SERVICE BULLETIN

No. 211

Piper Aircraft Corporation

SUBJECT: Main Fuel Cell Cavity Modification

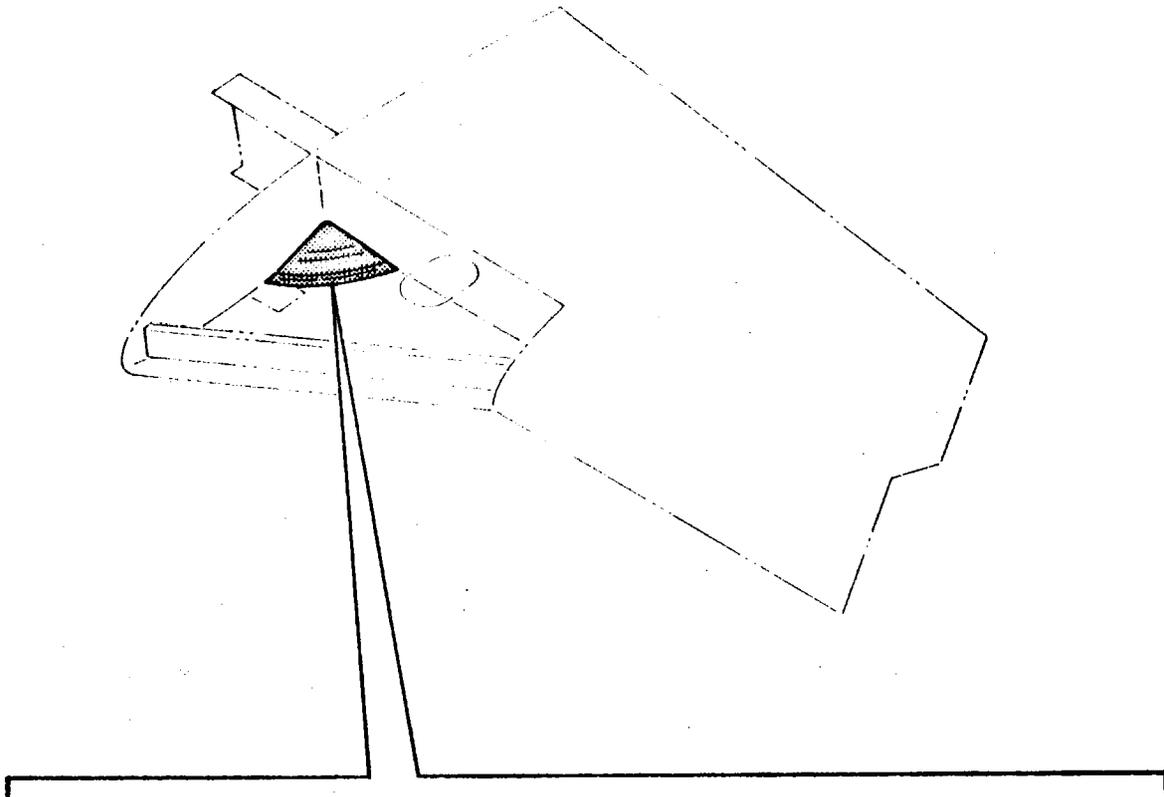
7. After fuel cell is folded forward, inspect the cell cavity and remove any foreign matter that may have accumulated.
8. Position the left shim 23677-00 or right shim 23677-01 in the rear inboard corner of the fuel cell cavity with the part number up. Insure proper clearance is maintained for the fuel outlet line. Trim forward edge of shim along edge of sump area.

9. With the shim held in place, mark around its edge with a marking pencil.
10. Coat the bottom side of the shim and the cavity area inside the line with 3M EC776 cement. Allow the cement to set approximately five (5) minutes, then install shim in its proper location.

11. Apply moleskin to the shim edge as shown per Sketch "A".
12. After unfolding the fuel cell within the wing, fasten the cell within the compartment and work out all wrinkles.
13. Replace sender unit assembly.

CEMENT IN PLACE
(SIDES & BOTTOM) USING
3M CEMENT EC776

TRIM CORNER
AT LINER-BOTTOM
OPENING

MOLESKIN TAPE 2"X19"
OVER EDGE
